## **Presentations for June 22, 2017 Public Meeting Regulatory Improvements for Advanced Reactors**

# **Public Meeting on Possible Regulatory Process Improvements for Advanced Reactor Designs**

June 22, 2017

## NRC Review of LBE and PRA White Papers

# F-C Curve Characterization

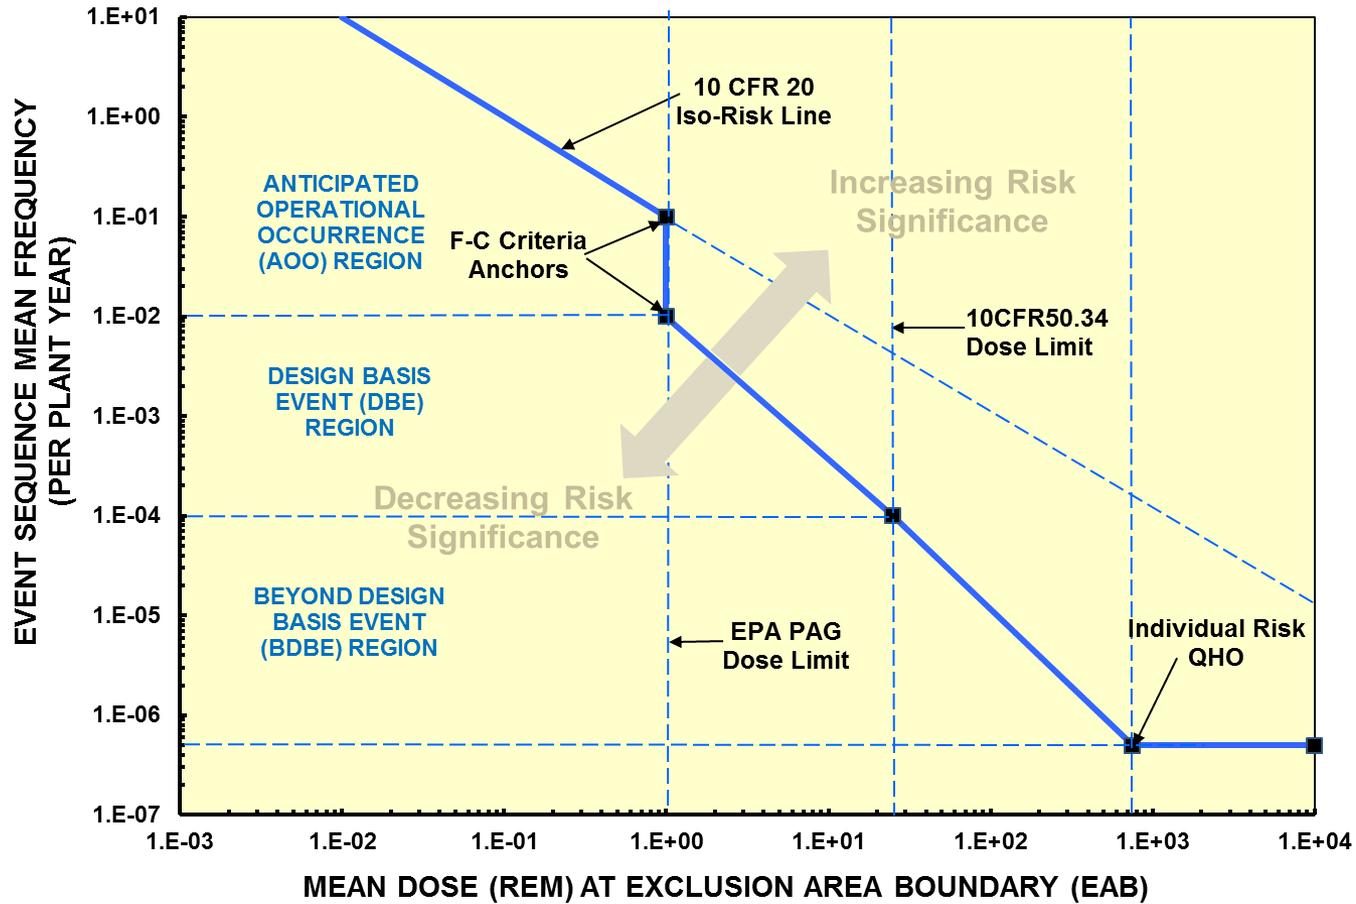
- Re-characterize the frequency-consequence figure and describe it as not defining specific acceptance criteria for analyzing Licensing Basis Events (LBEs) but providing a tool to focus the attention of the designer and those reviewing the design and related operational programs to the most significant events and possible means to address those events.

- Agreement on key points in the comment
  - F-C chart is not intended to be “risk acceptance criteria”
  - Provides useful way to demonstrated enhanced safety margins
  - Focuses on most (risk) significant events
  - F-C curve is not TLRC but rather derived from TLRC
- F-C chart primary purpose is to evaluate the risk significance of LBEs and to use as a tool in selecting and evaluating individual LBEs
